Referral Responses

Department	Comments
Urban Design	<p>In response to the DDO30 provisions, the proposal is excessive.</p> <p>DDO30 vision seeks to ensure that buildings in Montague North are “a mix of mid and high-rise scales with hybrid and podium–tower typologies” and, among other things “to encourage adaptable floorspace to facilitate a reduction in car dependence and an increase in commercial floor space over time.” Further, Area M1 in DDO30 suggests that predominately mid-rise development of 7-15 storeys, with some taller elements of around 20 storeys is envisaged.</p> <p>The proposal of 30 storeys diminishes the preferred building height of predominantly 7-15 storey developments and presents a proportion and form that should seek to diminish its visual impact. It is recommended the proposal quote the roof form from the development at 253 Normanby Road that reduces its massing and visual bulk with a sloping upper level facet providing visual interest at upper levels and reducing its overshadowing potential.</p> <p>The podium presents 5 storeys of un-sleeved carparking that is not appropriate for the precinct and provides an interface to a proposed public space foregoing the

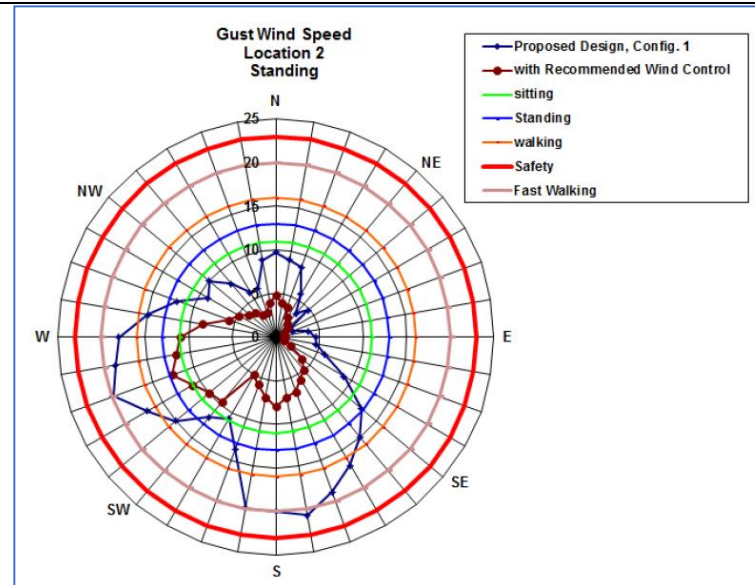
- (d) The assessment criteria specifications used need to accord with those required under Clause 2.11 of DDO30. A comparison with those adopted in the 2016 wind assessment (refer to Section 3) in the table below, which highlights the discrepancies (refer also to Figure 12 from report, provided below):

Criteria	Wind Impact Assessment	DDO30 Requirement	Difference
Safety	>23m/s annual maximum gust speed (Table 1 and Appendix A)	20m/s hourly maximum 3 second gust with a corresponding probability of exceedance	DDO30 more stringent
Walking	<16m/s annual maximum gust speed (Table 1 and Appendix A)	<= 5m/s hourly mean wind speed with a 20% probability of exceedance	DDO30 different measurement
Standing	<13m/s annual maximum gust speed (Table 1 and Appendix A)	<= 4m/s hourly mean wind speed with a 20% probability of exceedance	DDO30 different measurement
Sitting	<11m/s annual maximum gust speed (Table 1 and Appendix A)	<= 3m/s hourly mean wind speed with a 20% probability of exceedance	DDO30 different measurement

- (e) The mandatory wind safety criteria in DDO30 must be achieved in the amended wind assessment. Where the safety criterium is already exceeded under existing conditions, the development must not increase the extent of non-compliance;
